To: Putnam Inland Wetlands & Watercourses Commission

From: Delia P Fey, AICP, 570 River Road – property owner

Date: November 29, 2022

Re: Application 2022-09 285 River Rd LLC, Putnam River Rd LLC – 11 lot subdivision and gravel excavation

Close-up of Excavation Plan No. 2:
Area of the bridge

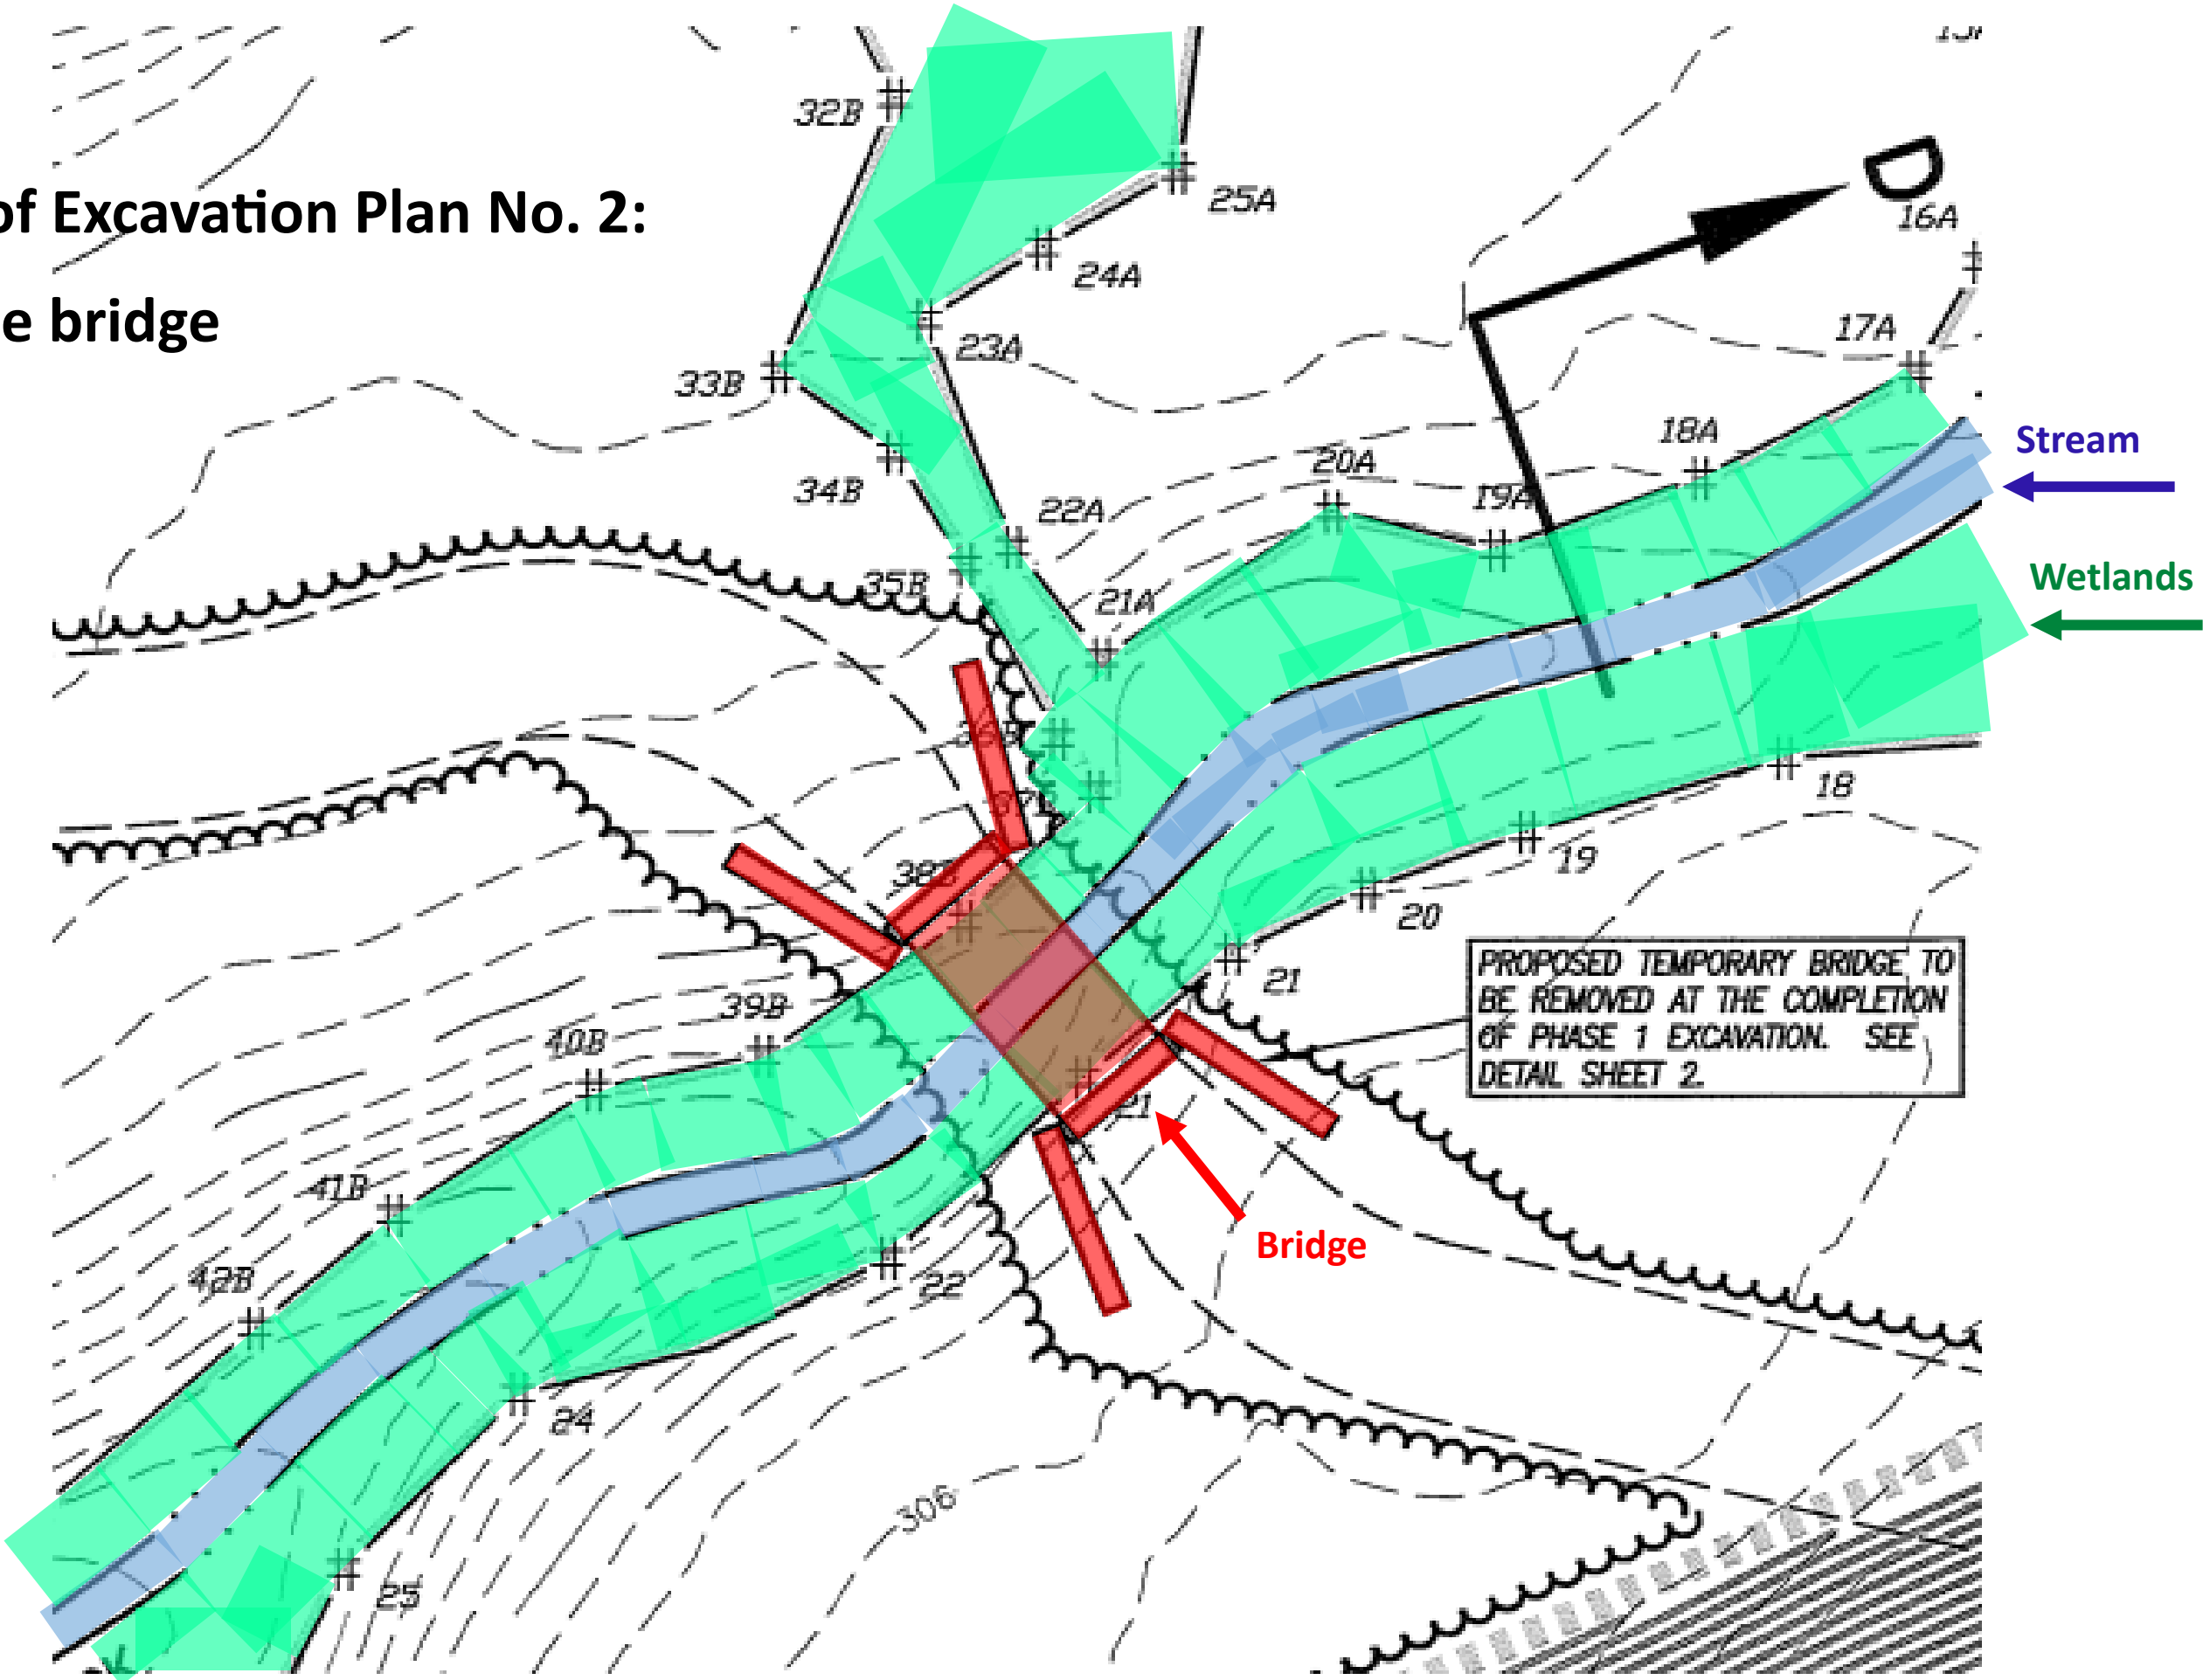
- b. The proposed bridge is indicated as 'temporary' however it is to have abutments that are backfilled which seems to indicate it will be installed with heavy equipment to cross a watercourse that was previously designated important enough to deem an upland review area that is *twice* as large as other watercourses in town.

- i. The installation of the bridge should include erosion and sediment controls to be used during installation as well as dewatering areas for any earth material, removed from within the area of the streambed and wetlands, in order to create the stable bridge capable of bearing the load of heavy trucks and equipment passing over it.

- ii. The stream no doubt has debris, boulders and other material that is in the way or otherwise not suitable as a foundation for the bridge abutments which will need to be **removed**, not to mention the 24 inches the abutments are required to be **embedded** into the surrounding grade which requires **excavation of 24 inches of the existing material very close to the edge of the wetlands and stream** to meet this detail of the plan. These details are in the "Detail Sheet No. 2" of the plans. The excavation and the embedding of the abutments indicate regulated activities are proposed either within the wetlands if not the stream itself and definitely within the Upland Review Area. **For this reason, a complete E&S plan should be required with the complete plans and the crossing should be reviewed by the town's engineer.**

- c. Not sure if the thick dotted grey line at the top of the proposed excavation slope is the E&S controls because it's not in the legend and the E&S controls near the houses is black not grey.

3. The temporary grading at the top and outer edge of the gravel pit shows a 12 ft drop over 14 ft or a **very steep slope** (85.7%). Considering we heard at the last meeting that trespassing occurs in this area, a fence should be required at the top of the slope to prevent anyone from encroaching on the gravel pit, particularly on lot 6, where the house is shown only 60 ft from the top of the slope, with the yard going right up to the slope.

Detail Sheet No. 2

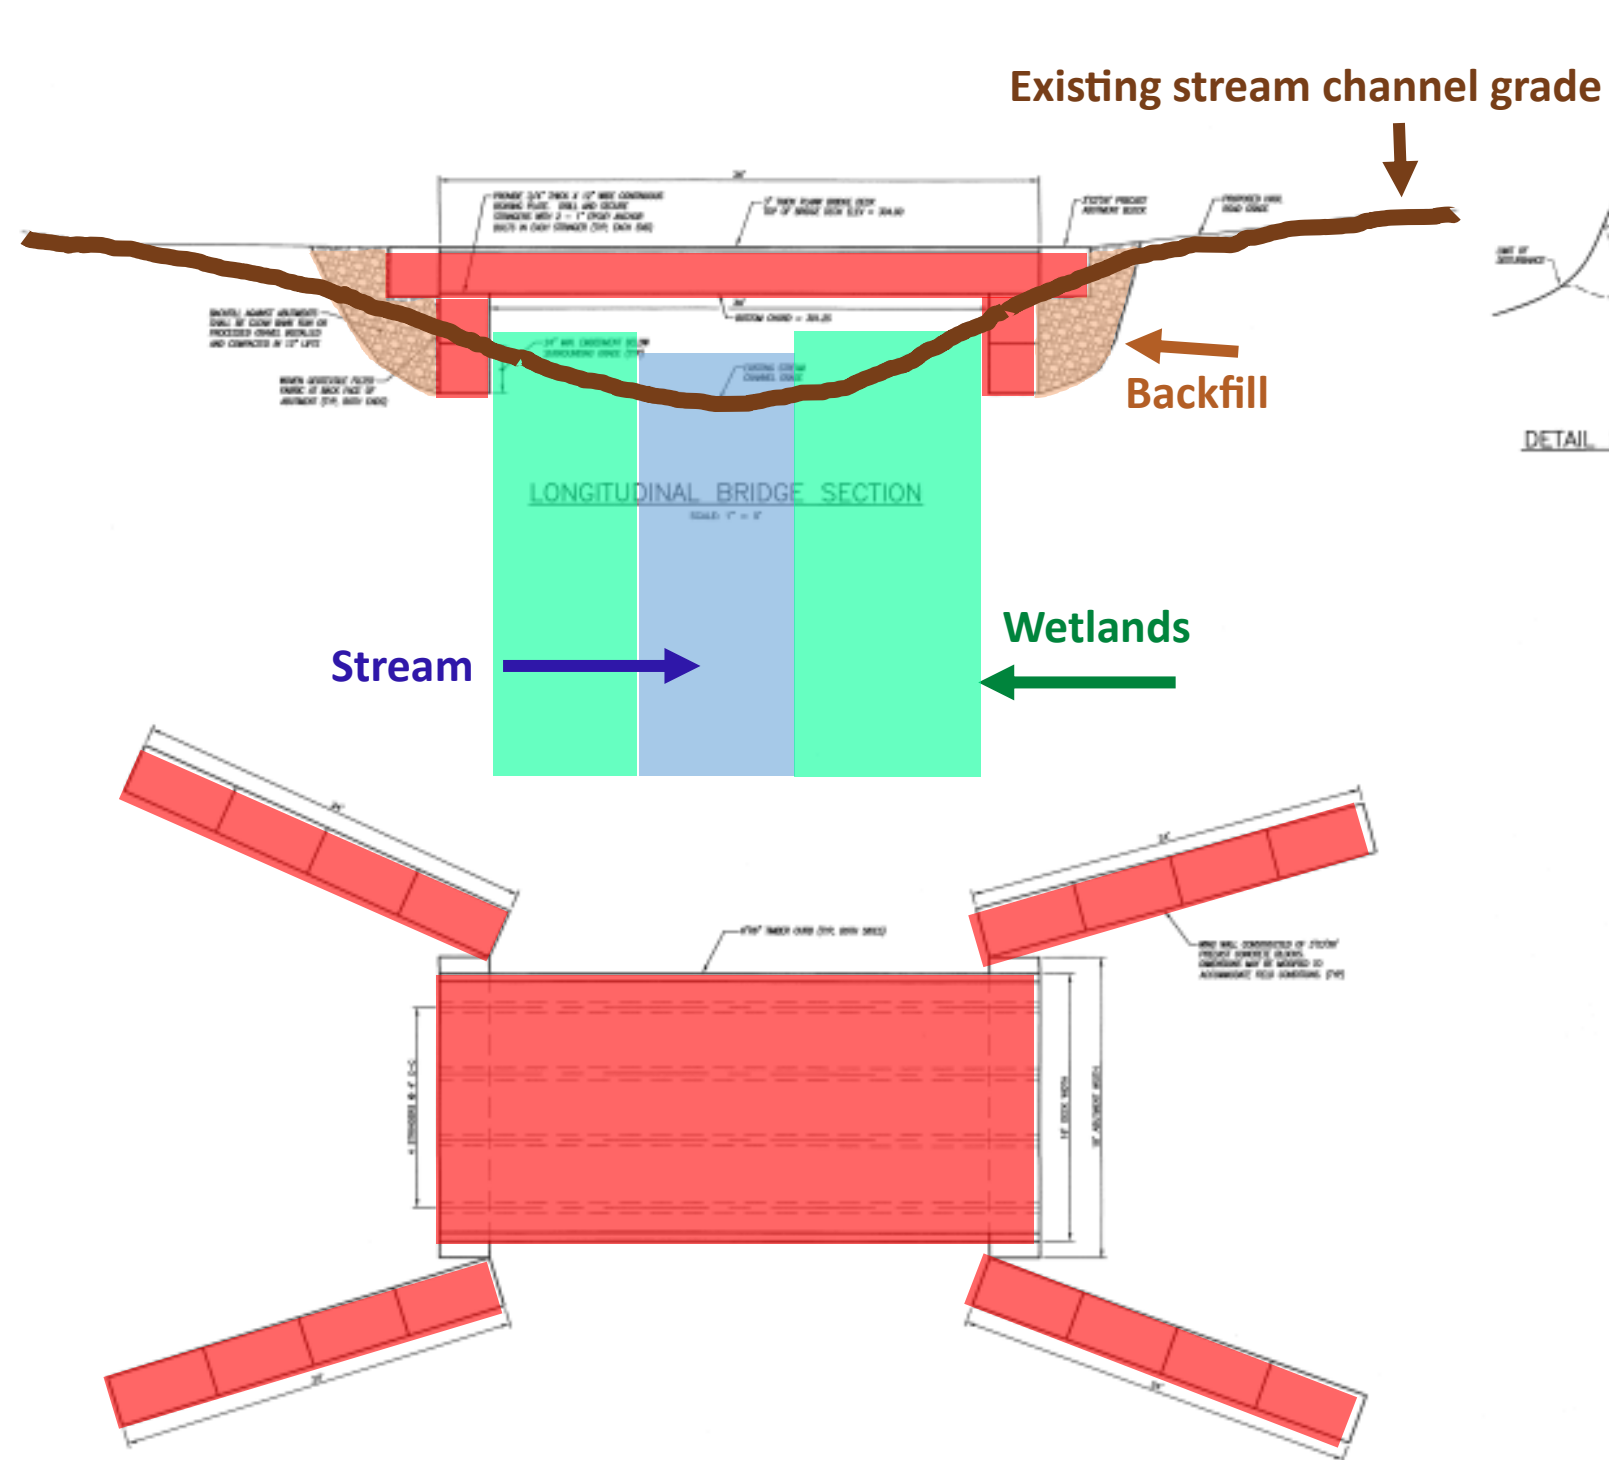
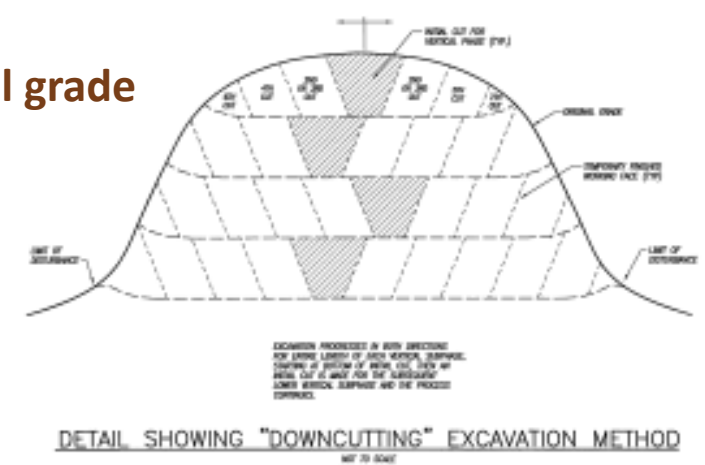
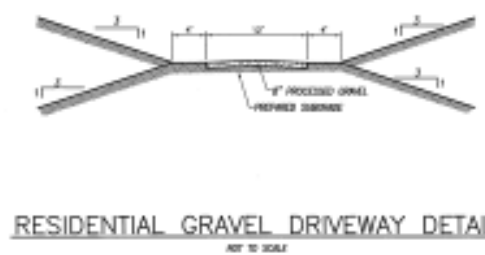
This stream crossing involves 2 ft excavation immediately adjacent to if not within wetlands with additional filling for the required backfill, again **very** close to wetlands and the stream. Although the bridge is “temporary” it still involves excavation and backfilling.

Note: This building is temporary too as it will someday come down.
